6B-SST CHANNEL & SOFTSTART SCHEMATIC Revision 1A 25 JULY 2002

6BSST

CHANNEL + SOFTSTART SCHEMATIC

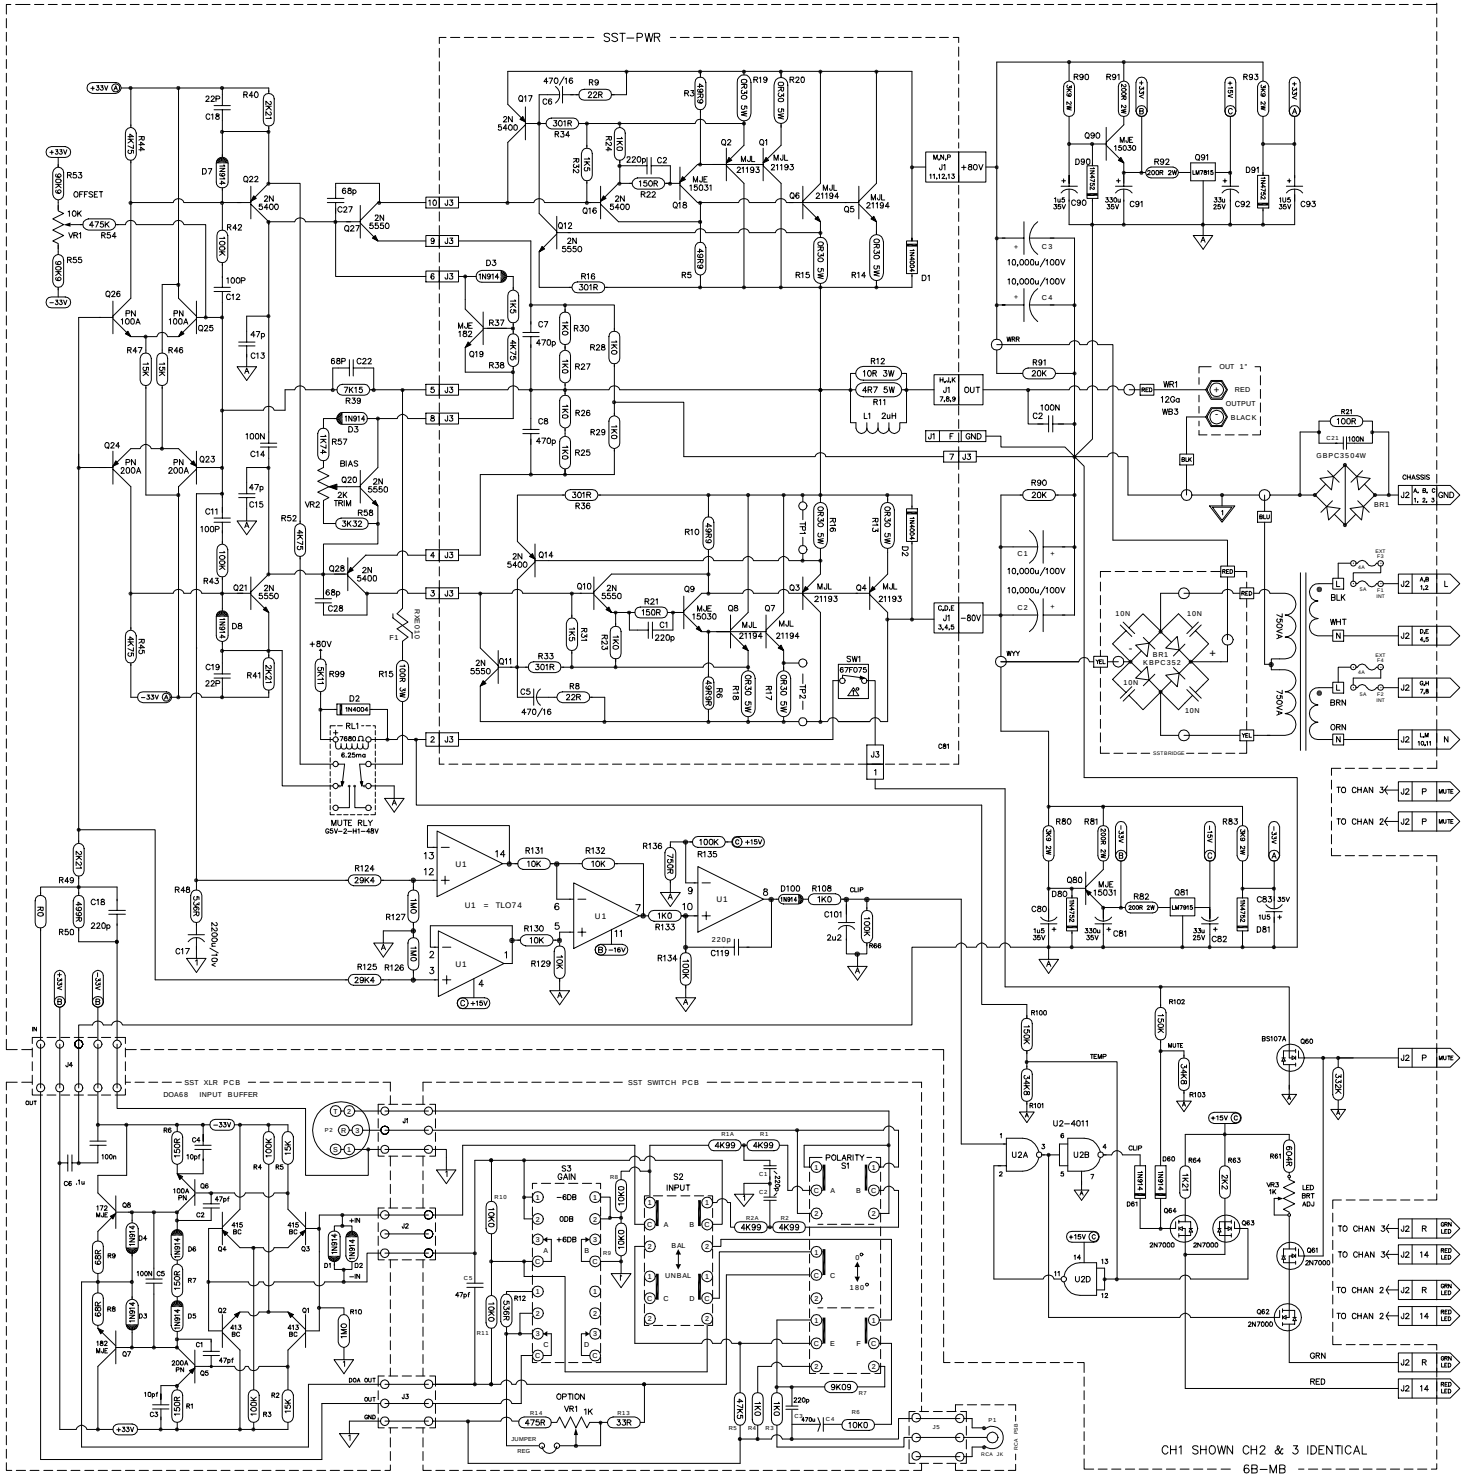
REV 9A ADD R10 TO DOA (+) INPUT
CHANGE R16, 33, 34 + 36 TO 301R ECO-616
